Hours per Year Based on opm.gov for computing hourly rates of pay  
Hours per Month

Previous 2017  
SEU Employees \$ 99,283.00  
SEU Contractors \$ 68,235.00

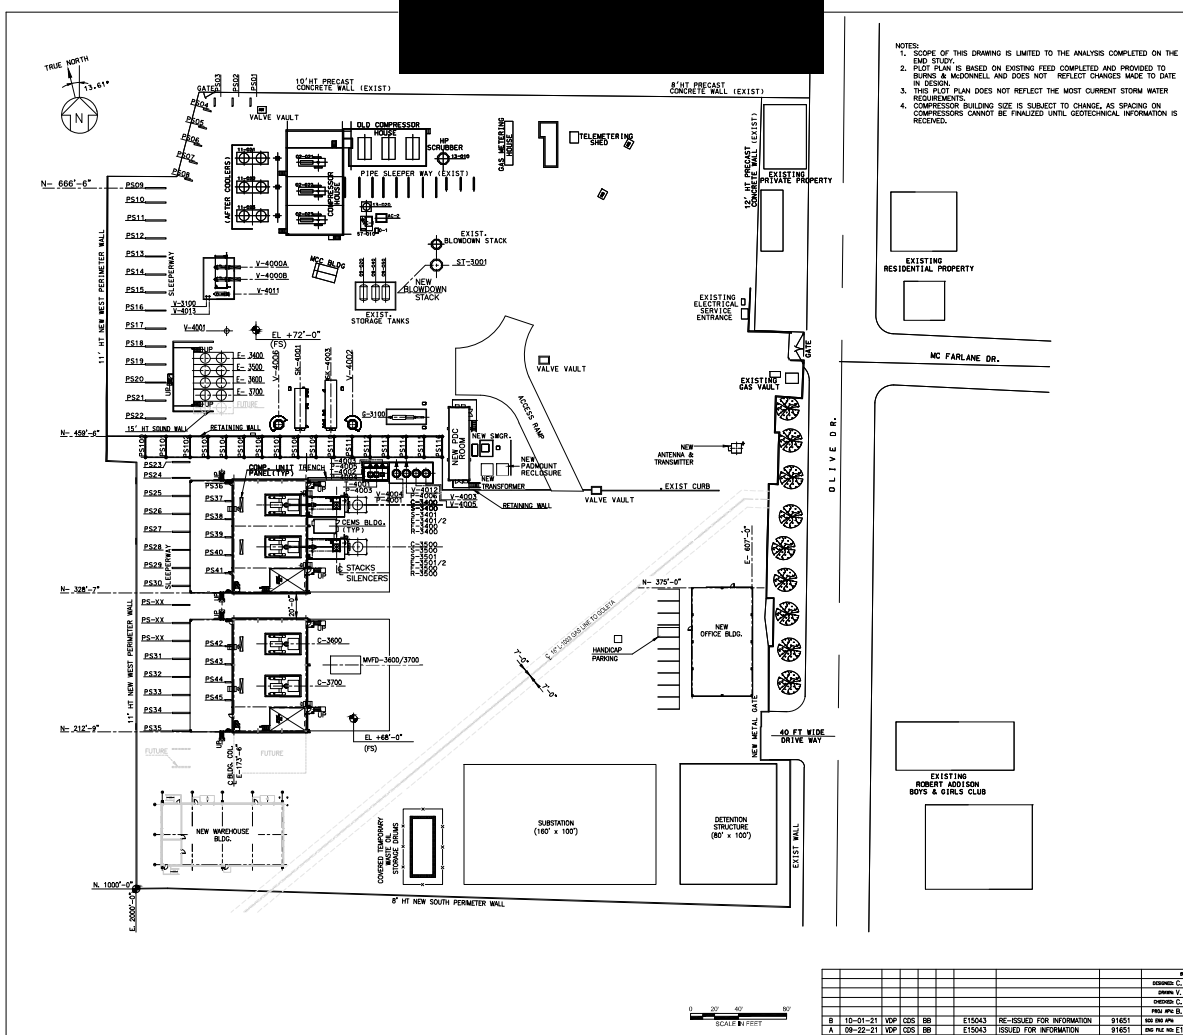
EMD OPTION BID EVALUATION				
		Owner: SoCalGas	Clarification is required			Revision: A
Project Number: 132609		Tech Not Acceptable			By: BEB	
Project Description: Ventura Compressor Modernization		Vendor Selected			Apprv: CBS	
Bid Description: EMD Option Bid Tab					Date: 8/31/2021	
Specification No.		Neuman & Esser	BMcD Comment	UECompression	BMcD Comment	
Proposal No.						
Quote Date		4/23/2021				
<b>DATA PROVIDED</b>						
PERFORMANCE CALCULATIONS PROVIDED	Requested	YES		YES		
PRELIMINARY P&IDS	Requested	NO		NO		
PRELIMINARY GENERAL ARRANGEMENT	Requested	YES		YES		
<b>MOTOR</b>						
MOTOR HP RATING	1900 HP+	2500 HP		2300 HP		
MOTOR RATED RPM	1200 RPM	1200		1200		
MOTOR VENDOR	By Vendor	TECO		WEG / SIEMENS / TECO / ABB / NIDEC / OTHER		
POWER RATING	4160v	4160V/3ph/6hz		4160V/3ph/6hz		
SKID SIZE	By Vendor	31' x 18'		28.7' x 12.5'		
VFD	Manufacture	TECO VersaBridge - NEMA 1 Medium Voltage 2500 HP		WEG VSD Series MVW3000
